**TECHNICAL EVALUATION REPORT  
CHRISTENSEN RANCH MINE UNITS 2 THROUGH 6 RESTORATION REPORT  
URANIUM ONE USA, INC., WILLOW CREEK ISR FACILITY**

**DATE:** October 23, 2012

**DOCKET NO.:** 040-08502

**TECHNICAL REVIEWERS:** John L. Saxton, Elise A. Striz

Figure 3c. MU2 North and South Radium-226 Stability Monitoring Trend Analysis

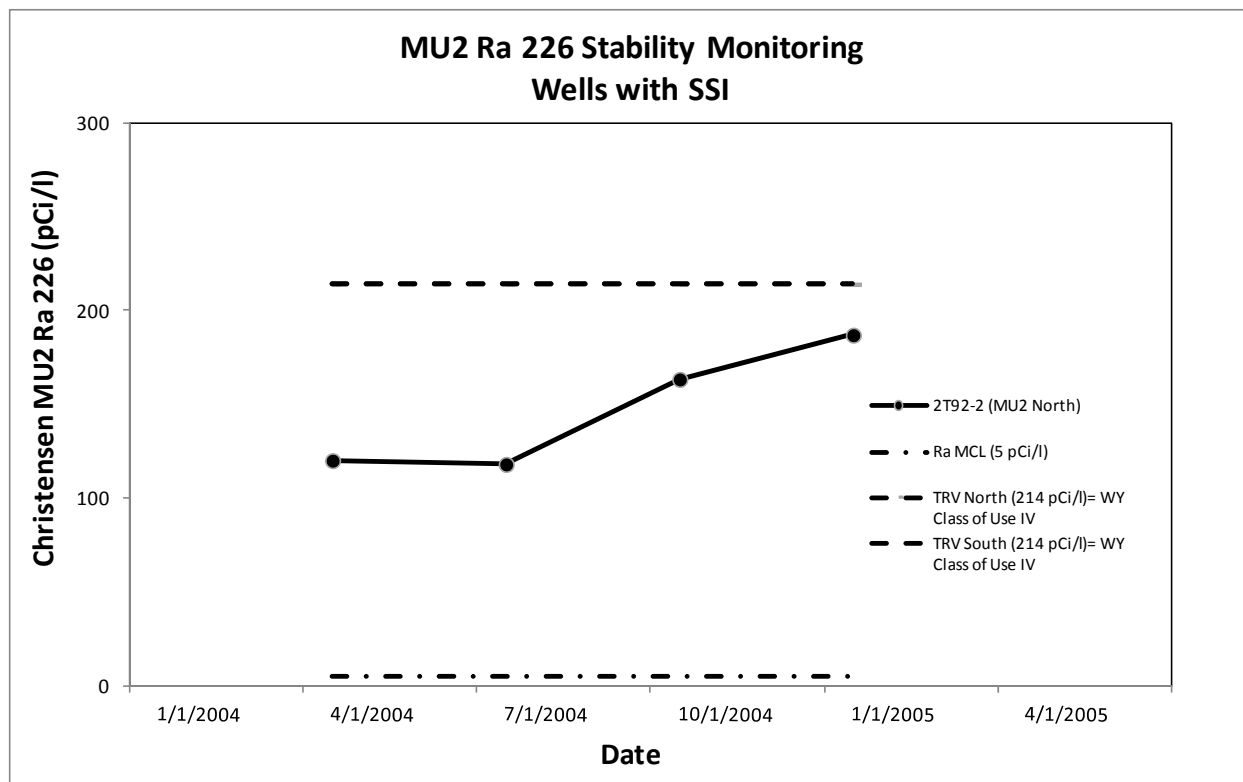
The SSI trend for Mine Unit 2 South for uranium in this well is shown in Figure 3c. It is of concern to the staff because it shows that uranium in this well is above the Class IV standard (background TRV) and is increasing.

- (1) Demonstrate that the SSI trends for uranium and radium-226 at well 2T92-2 are reversed and stable.
- (2) Provide a confirmatory analysis of the groundwater quality at well 2MW108 subsequent to the corrective actions for the 2011 excursion that demonstrates impacts to the aquifer following the 2011 excursion event meet regulatory requirements (groundwater protection criteria).
